**UNITED STATES
NUCLEAR REGULATORY COMMISSION**
WASHINGTON, D.C. 20555-0001

FACILITY: Donald C. Cook Nuclear Plant, Units 1 and 2

SUBJECT: SUMMARY OF AUGUST 26, 2009, CATEGORY 1 PUBLIC MEETING VIA CONFERENCE CALL TO DISCUSS RESPONSES TO GENERIC LETTER 2004-02 REQUESTS FOR ADDITIONAL INFORMATION (TAC NOS. MC4679 AND MC4680)

DRAFT
Response to June 18, 2009 Request for Additional Information (RAI)
To Support August 26, 2009 Teleconference Between
Nuclear Regulatory Commission (NRC) And D. C. Cook Nuclear Plant (CNP)

Figure 7.a-1: Data Erosion Rate and Predicted Cumulative % Weight Loss Curve (Thermo-12™ Gold)

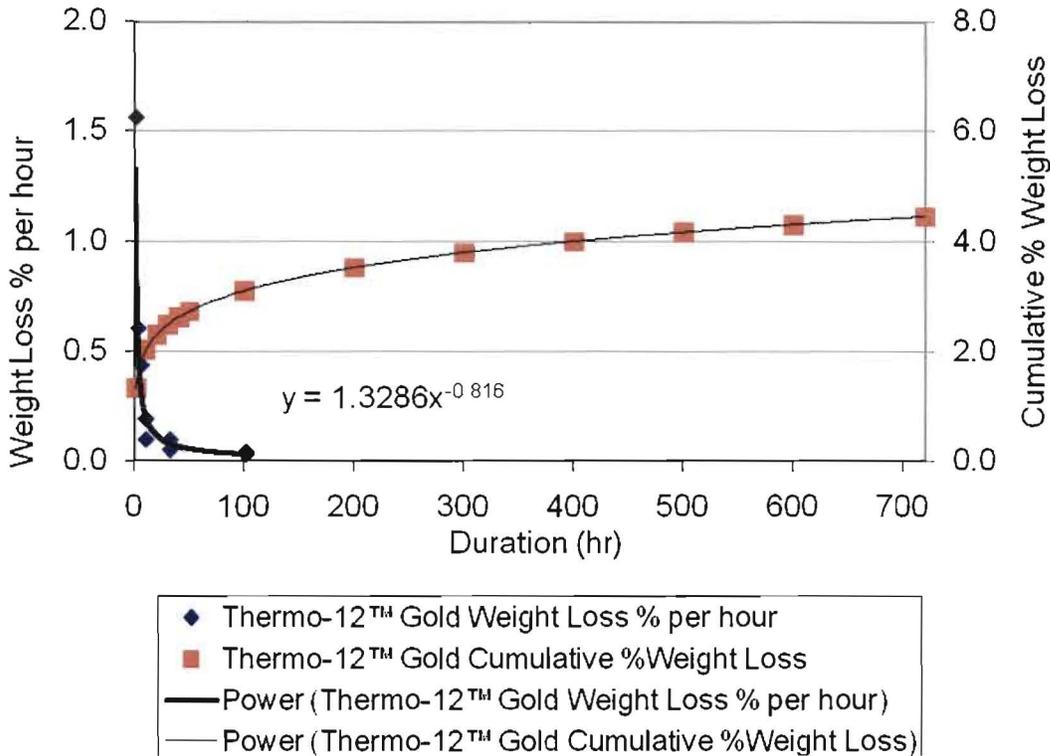
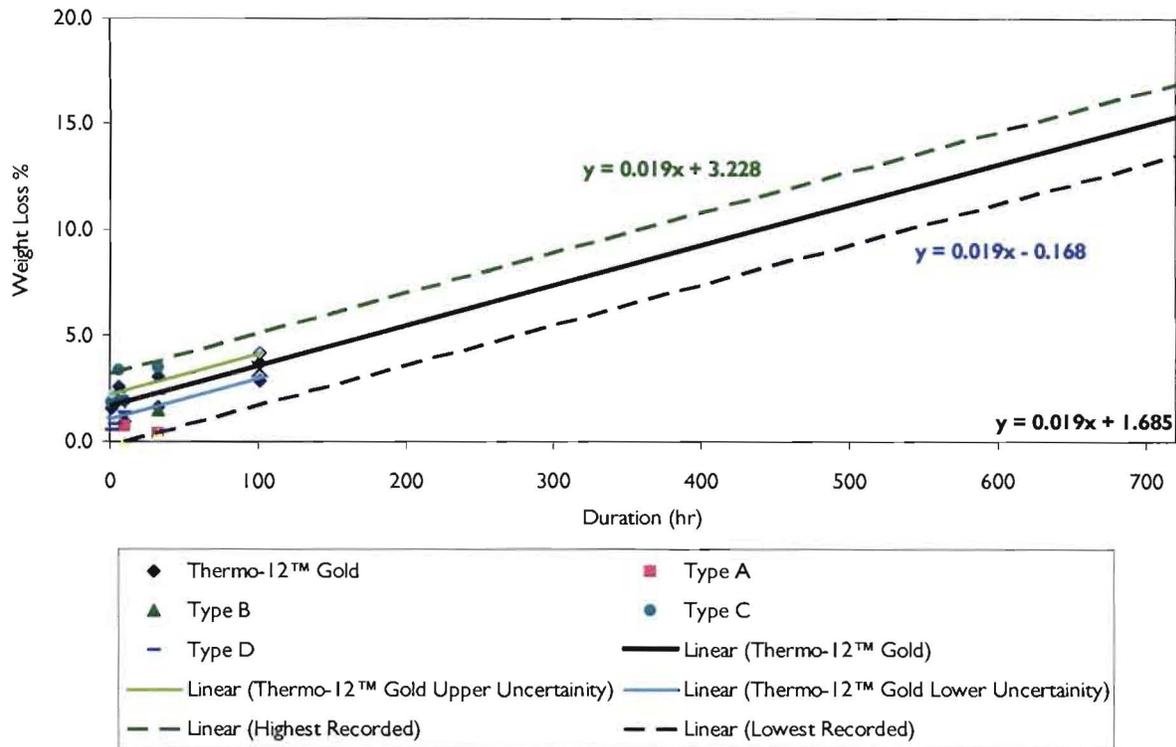
7. *Please provide additional information concerning the erosion testing of calcium silicate insulation and Marinite board, including the following items:*
 - a) *The basis for not accounting for erosion and dissolution effects in combination. The presence of chemicals in the test fluid may enhance the erosion rate, and, conversely, a high erosion rate may lead to increased dissolution.*

The data collected during Thermo-12™ Gold flow erosion testing was analyzed in the Cal-Sil Flow Erosion Testing Report. The data in Figure 7.a-1 represents the rate of erosion of Thermo-12™ Gold Cal-Sil as presented in Figure 3.2-3 of Cal-Sil Flow Erosion Testing Report. The equation from 3.2-3 (i.e. $y = 1.3286x^{-0.816}$) is used to calculate the cumulative % weight loss data and the curve generated from this data is presented in Figure 7.a-1 as well.

During the conduct of the testing, one of the overall observations made was that during the initial stages of all tests, small amounts of particles detached from the samples. This behavior is most likely due to the washing of loosely attached pieces. The graph above shows the behavior that the majority of flow erosion occurs in the initial hours and then the rate of erosion continuously declines as time increases.

Extending the curve for cumulative % weight loss, the weight loss at 720 hours is 4.46%. Although the data plotted above indicates that the erosion rate may decrease with time, a linear curve fit was applied to the data as a more conservative method of extrapolation due to its application of a constant erosion rate as opposed to a power curve fit. Figure 3.2-2 of Cal-Sil Flow Erosion Testing Report (Figure 7.a-2) represents the linear curve fit. In addition to Thermo-12™ Gold Cal-Sil cumulative erosion, also displayed are values for four types of plant provided Cal-Sil cumulative erosion.

The curve fit of Thermo-12™ Gold was used to determine the total Thermo-12™ Gold erosion at the recirculation mission time of 30 days (720 hours) as obtained by extrapolation. The total weight loss of Thermo-12™ Gold Cal-Sil samples at 30 days is $(15.37 \pm 0.59)\%$ (using the equation $y = 0.019x + 1.6854$).

The upper and lower bounds of the weight loss as a function of time are calculated by sliding the linear curve fits up and down to the points that have the greatest difference between the measured value and the linear curve fit. These upper and lower bounding curve fits are used to determine the upper and lower bounding values of total Cal-Sil erosion at the recirculation mission time of 30 days (720 hours) i.e. 13.512% to 16.91% of initial mass.

Figure 7.c-1: Average velocity in non-transport regions for small pieces of Cal-Sil and Marinite

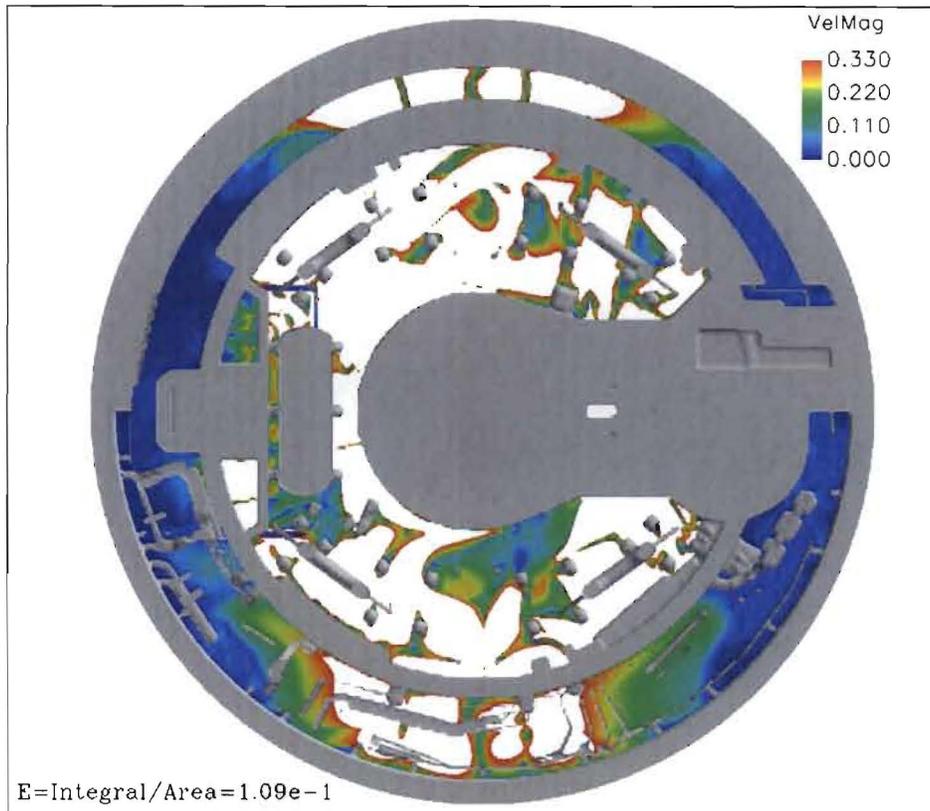
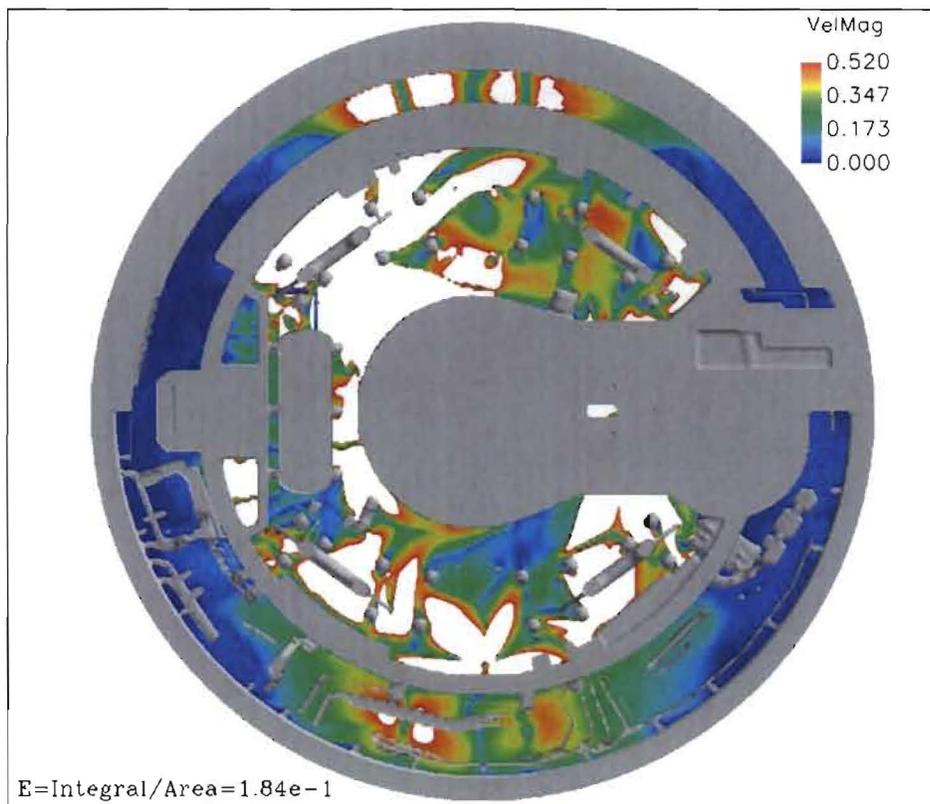
- c) *The basis for using a velocity of 0.4 ft/s, since calcium silicate pieces larger than those tested (i.e., in the large piece category) would not transport at this velocity based on the metric of 0.52 ft/s cited in Table 3e1-5 in the February 29, 2008 supplemental response. As a result of exposure to higher velocity flows than tested, erosion from settled large pieces of calcium silicate could be underestimated.*

The tumbling velocity that was used for small pieces of Cal-Sil and Marinite debris is 0.33 ft/s, and the tumbling velocity that was used for large pieces of Marinite debris is 0.52 ft/s. Since these pieces of debris would transport in any regions of the pool where the velocities are higher, the erosion would apply to debris that does not transport in the lower velocity regions. The recirculation pool CFD results from the limiting break case (Loop 4) were analyzed to determine the average velocity in the non-transport regions. As shown in Figure 7.c-1 and Figure 7.c-2, the average velocity in the non-transport regions was determined to be 0.11 ft/s for small pieces of Cal-Sil and Marinite, and 0.18 ft/s for large pieces of Marinite. Since these velocities are significantly lower than the 0.4 ft/s velocity used for the erosion tests, the erosion testing can be conservatively used for both the small and large pieces of Cal-Sil and Marinite at D.C. Cook.
